WESTERN VIRGINIA REGIONAL - CONSTRUCTION DETAIL

Ŏ **CLEARBR**(0 RENOVATION

PROJECT NO: 60153682.0001

W-18

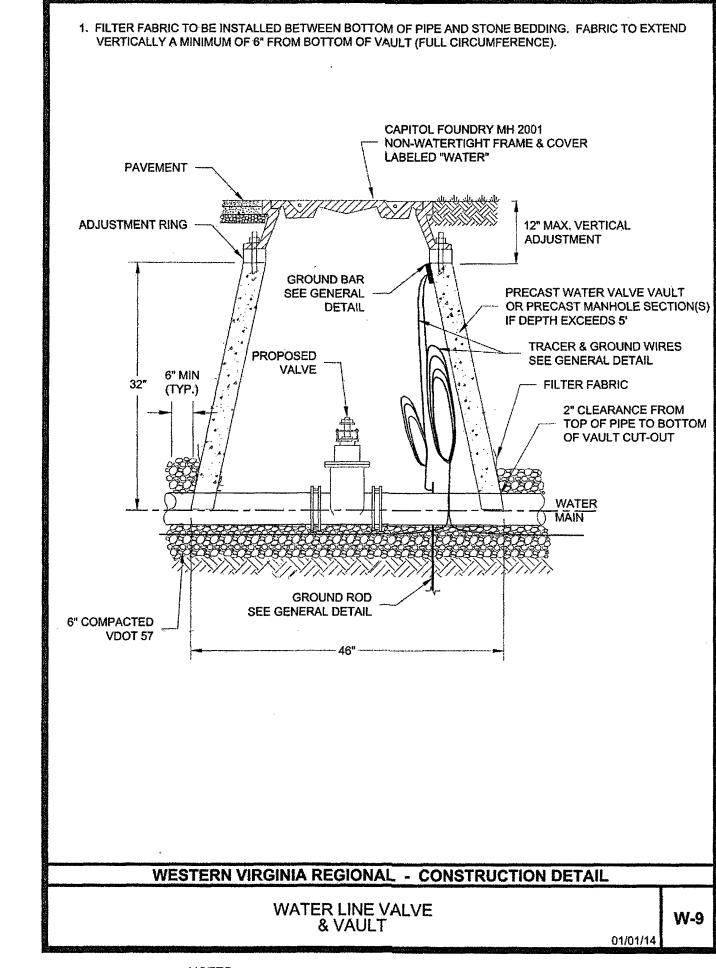
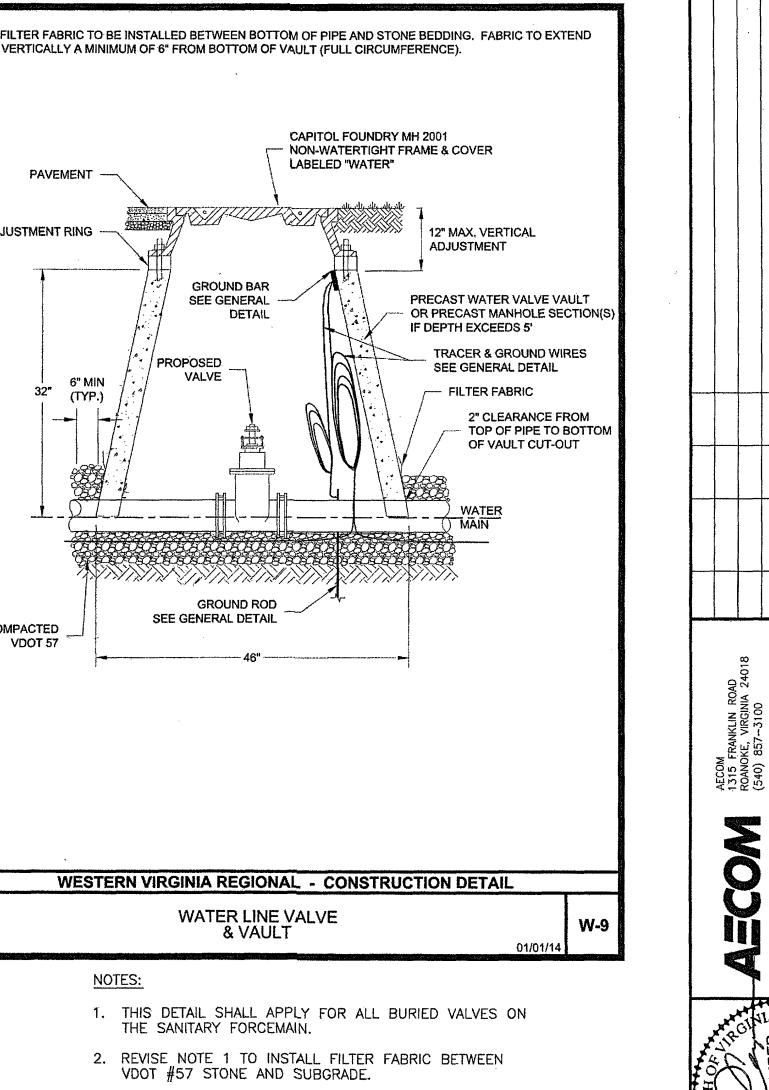
- 1. THIS DETAIL IS A STANDARD DETAIL FOR THE WESTERN VIRGINIA WATER AUTHORITY. PIPING INSIDE VAULT AS INDICATED IN THIS DETAIL SHALL BE REPLACED WITH PIPING AND MAGNETIC FLOW METER AS INDICATED ON SHEET CS501.
- 2. "UNI-FLANGE" ADAPTER FLANGES SHALL NOT BE PROVIDED. PROVIDE RESTRAINED FLANGE COUPLING ADAPTERS AS INDICATED ON SHEET CS501.
- 3. REVISE NOTE 7 TO INSTALL FILTER FABRIC BETWEEN

VDOT #57 STONE AND SUBGRADE.
